CHANGE ORDER REQUEST

No. COR 124R

Project Name Tolleson Union High School No 7

Scope Description

DRAWING NO:
SL2
OF 6

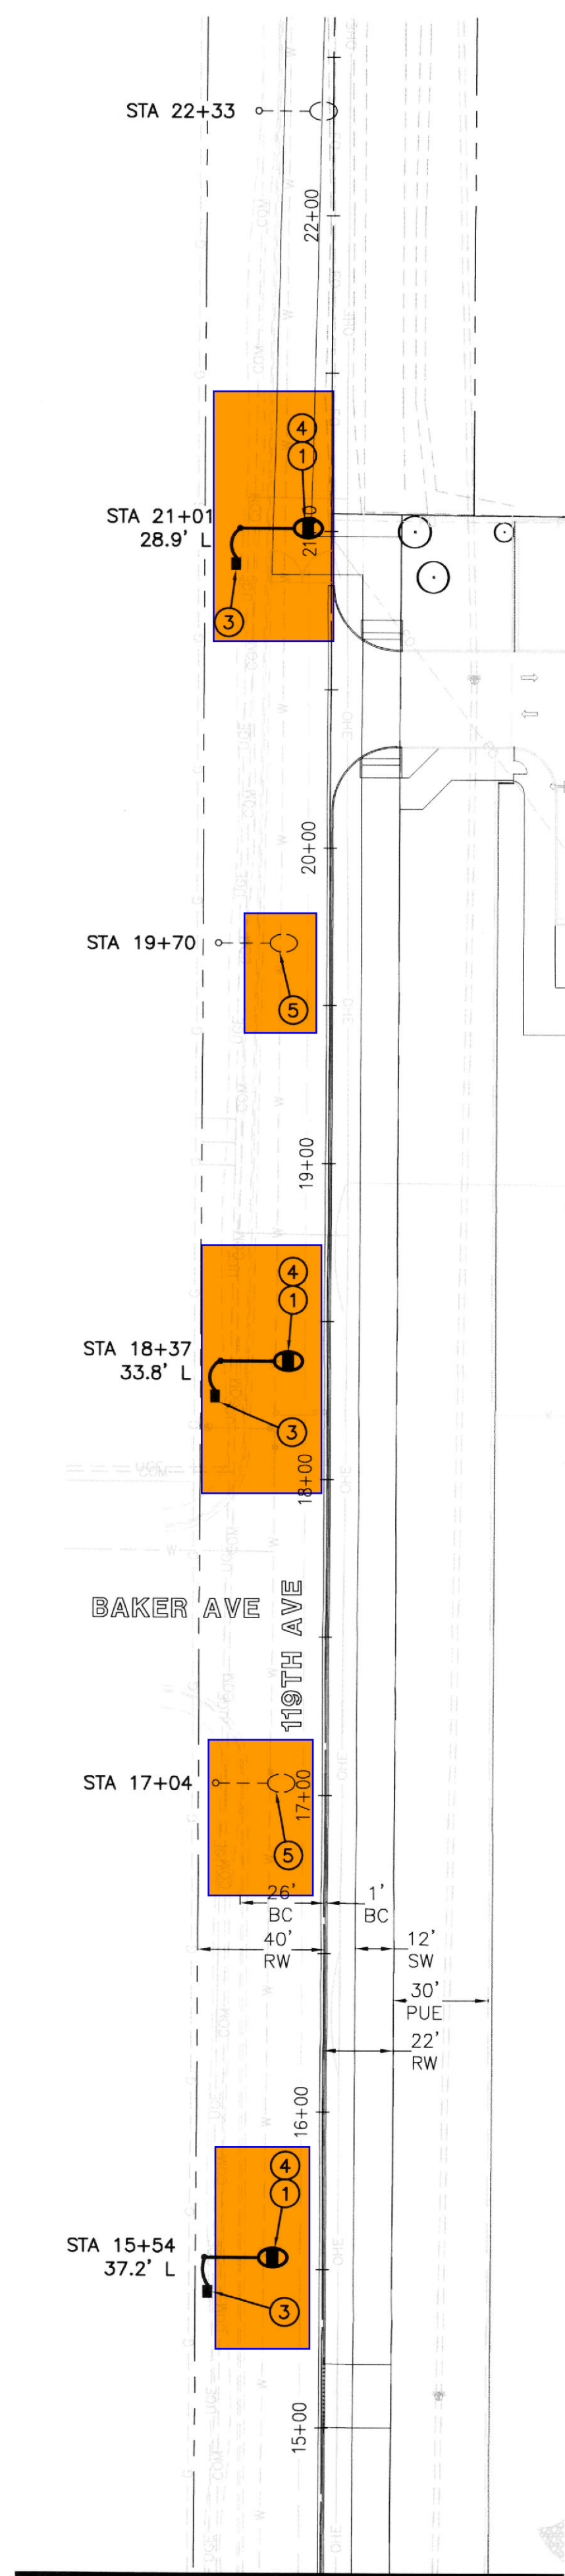
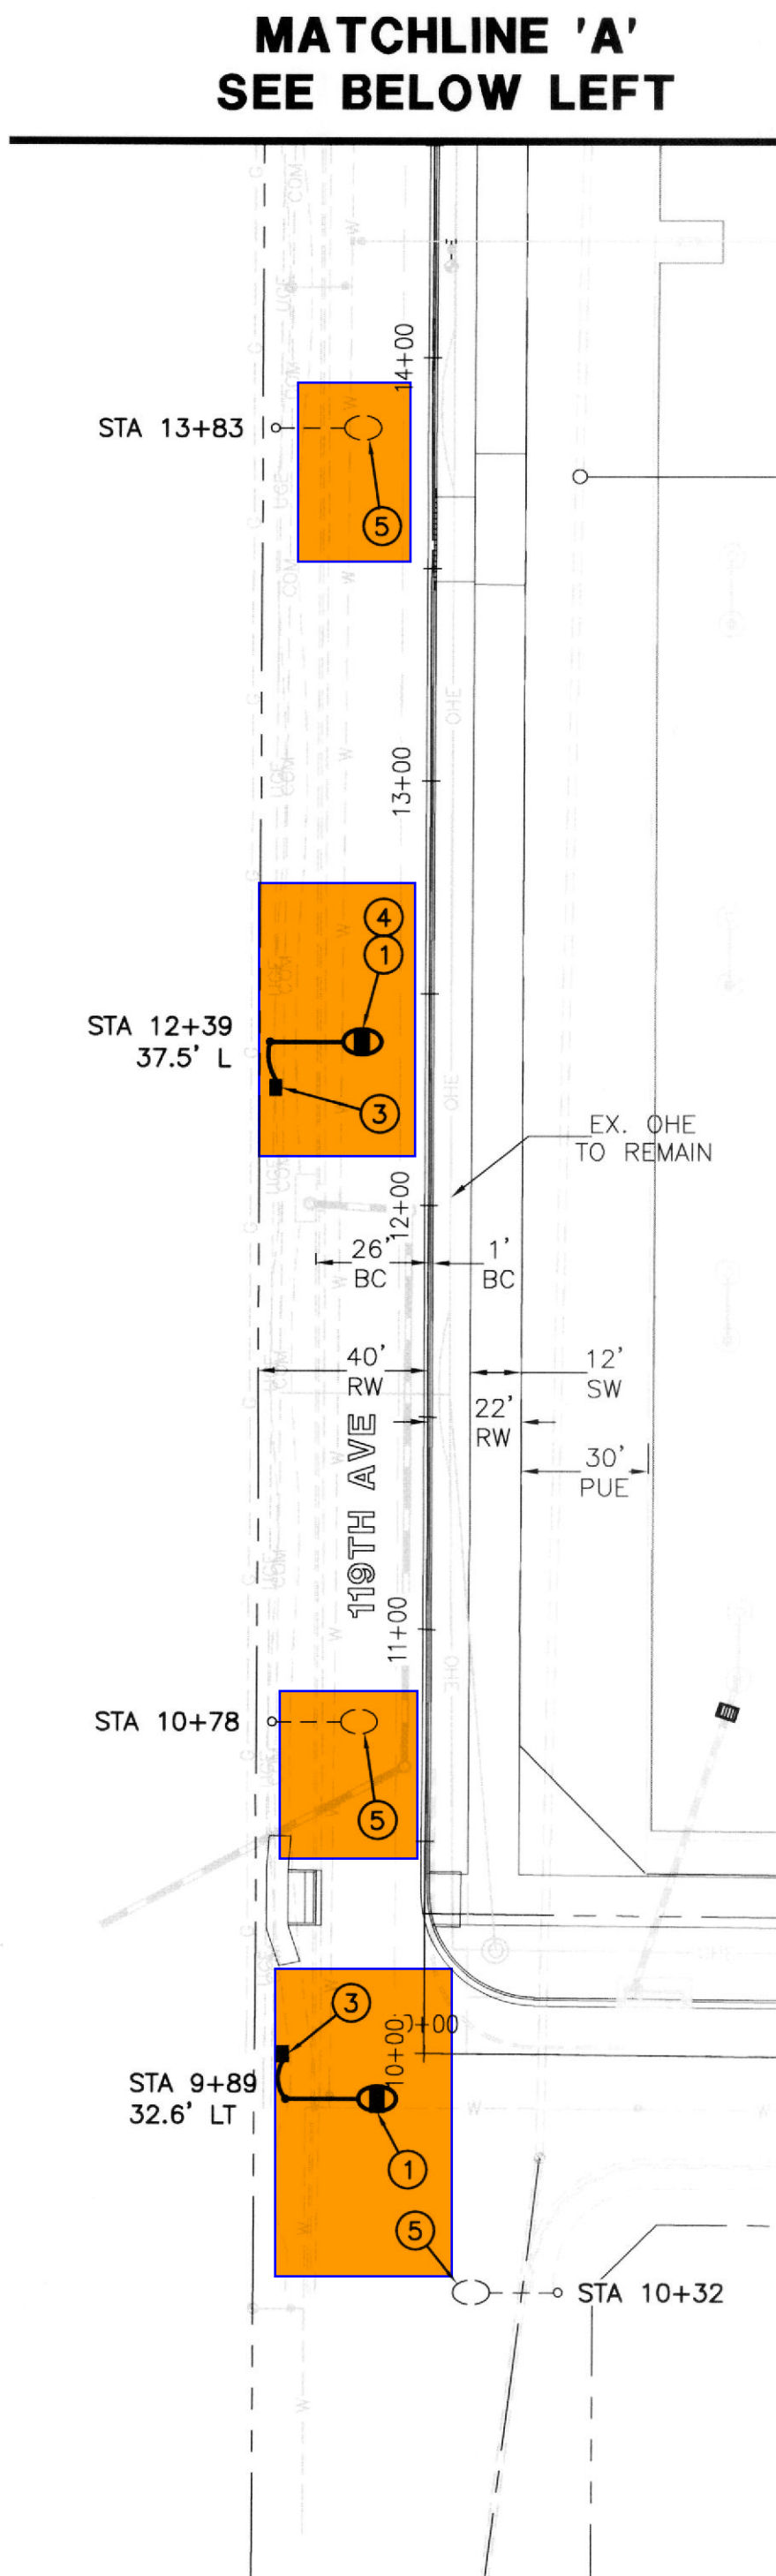
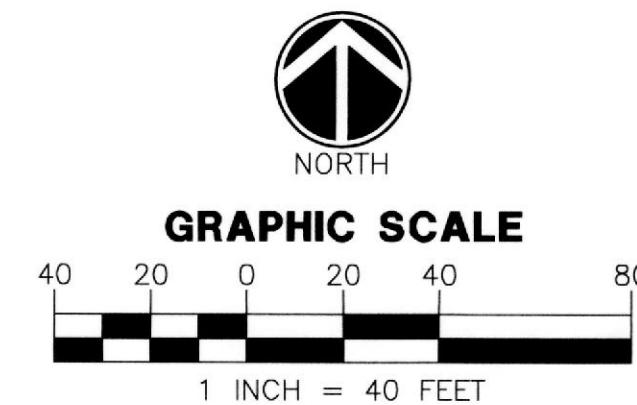
Provide additional lighting, trenching and conduit along 119th Avenue, Encanto Blvd & Avondale Blvd in Right of Way as required by regulatory agencies (SRP) to provide streetlights for pedestrian/vehicular access and egress to the school site.
